Office Action Summary

10/559,965

WEICKERT ET AL.

DETAILED ACTION

Applicants' invention is related to the reactor system as depicted in Figure 1 below.

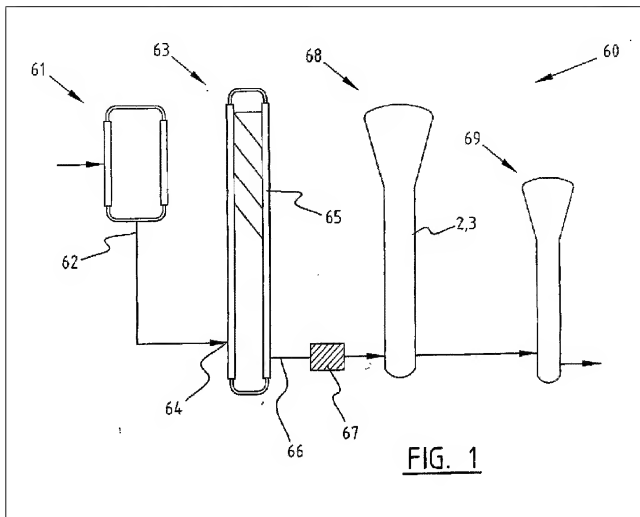
Claim 23 (line 12), the word "means for controlling" in an attempt to use a "means" clause to recite a claim element as a means for performing a specified function. However, since no function is specified by the word(s) preceding "means," it is impossible to determine the equivalents of the element, as required by 35 U.S.C. 112, sixth paragraph. See *Ex parte Klumb*, 159 USPQ 694 (Bd. App. 1967).

Claim 27(line 2), the word "means for removing" in an attempt to use a "means" clause to recite a claim element as a means for performing a specified function. However, since no function is specified by the word(s) preceding "means," it is impossible to determine the equivalents of the element, as required by 35 U.S.C. 112, sixth paragraph. See *Ex parte Klumb*, 159 USPQ 694 (Bd. App. 1967).

Claim 27(line 3), the word "means for separating" in an attempt to use a "means" clause to recite a claim element as a means for performing a specified function. However, since no function is specified by the word(s) preceding "means," it is impossible to determine the equivalents of the element, as required by 35 U.S.C. 112, sixth paragraph. See *Ex parte Klumb*, 159 USPQ 694 (Bd. App. 1967).

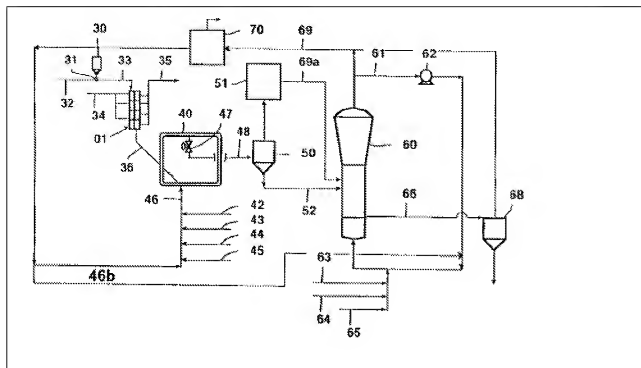
Harlin et al. (Figure 1) disclose a polymerization process for preparing polypropylene in a reactor system comprising pluralities of reactors. Harlin et al. (col. 11, line 17-48) clearly indicate that the polymerization process of Harlin et al. comprises a prepolymerization reactor (1), a first loop reactor (40), and a second gas phase (fluidized bed) reactor (60). Harlin et al. (col. 16, claim 24) clearly teach that a third gas phase reactor can be installed.

Regarding claims 8 and 9, Harlin et al. (col. 11, line 33, item 50) clearly disclose the presence of a flash separator for removing hydrocarbons and/or hydrogen, which are clearly present in the reactor (col. 8, line 35-40).

The difference between the invention as claimed and the process of Harlin et al. is that Harlin et al. do not teach process involving a second reactor comprising a moving bed under such conditions that the residence time in the fluidized bed and the residence time in the moving bed are independently controlled.
